FINAL TECHNICAL MEMORANDUM

Yucca Pens Hydrologic Restoration Plan

(Work Order No: 4600000893-WO03)

January 28, 2010
08006.02

Figure 2-2

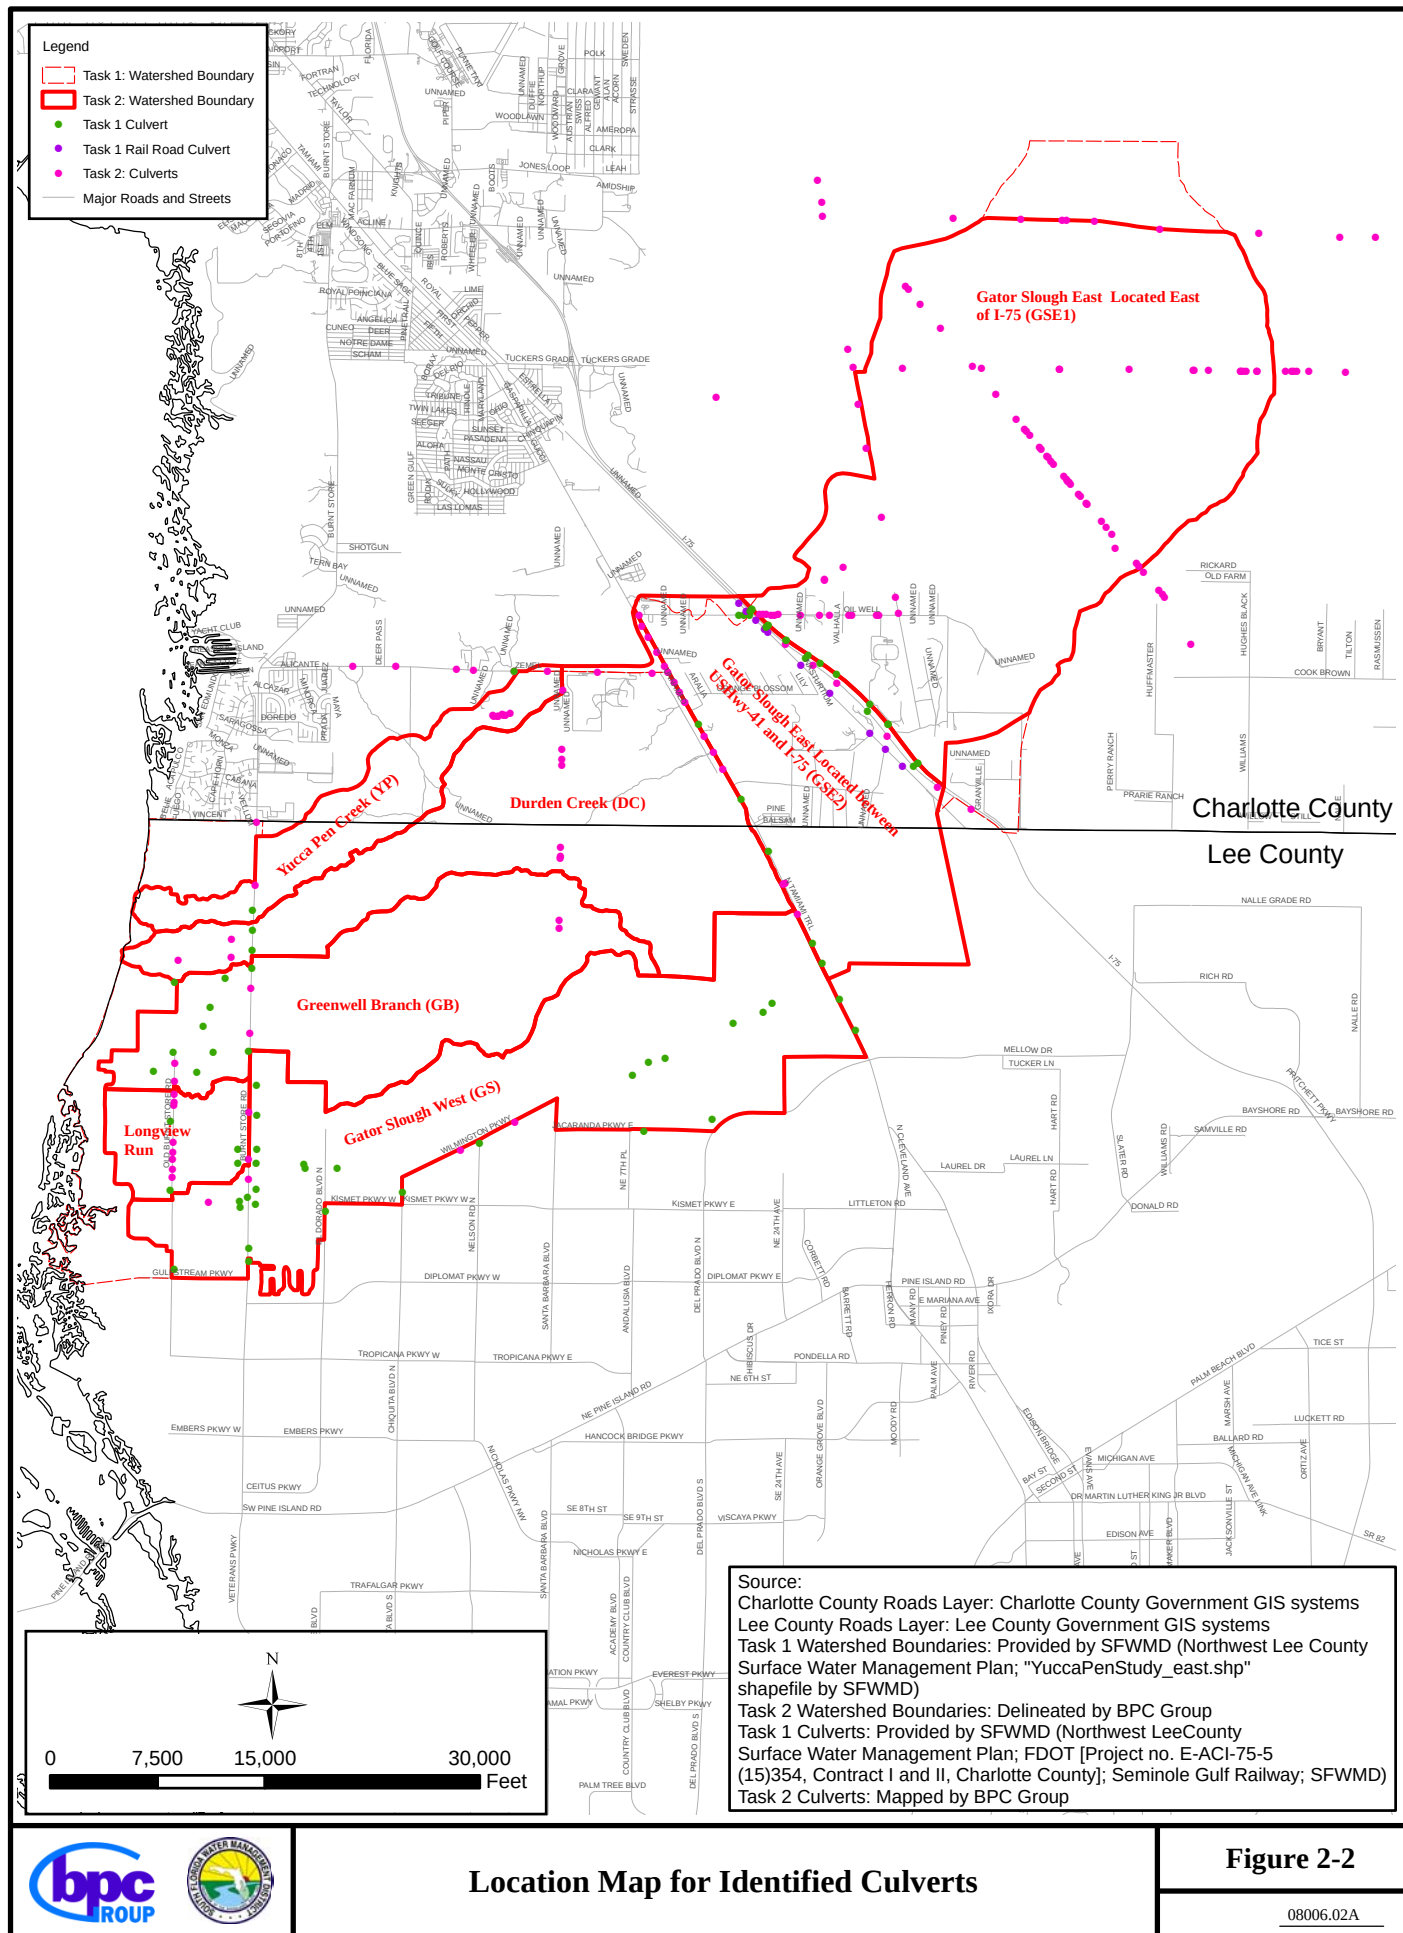
Section 2, Figure 2-2	Recommend showing those culverts which were identified as needing maintenance on the location map with a specific identifier (figure 2-2, Page 2-4) as referenced on Page 2-5, Lines 1-4.	John DeGiovine / Charlotte County Public Works	Current study is very limited in scope, which does not include a more comprehensive infrastructure survey that is needed for engineering analysis and maintenance plan. This may be considered in an engineering study.
Section 1, Page 1-6, Line 34	Change the word "Volume" to Rate to be consistent with current Water Management criteria.	John DeGiovine / Charlotte County Public Works	Incorporated. "Volume" was extracted from the original report.
General Comment	In general I am concerned that the recommendations will be considered as valid, with further design planning and installation of improvements, based on this document. A major missing part - which is recognized - is that the vertical data collected is with instruments that are not sensitive enough for this area of Florida. I think the document should include a listing of the limitations of the study at the beginning of the report.	Stephanie R. Smith, P.E. / City of Cape Coral	This TM repeatedly states that this is not an engineering document and that an engineering study is required for any design whatsoever.
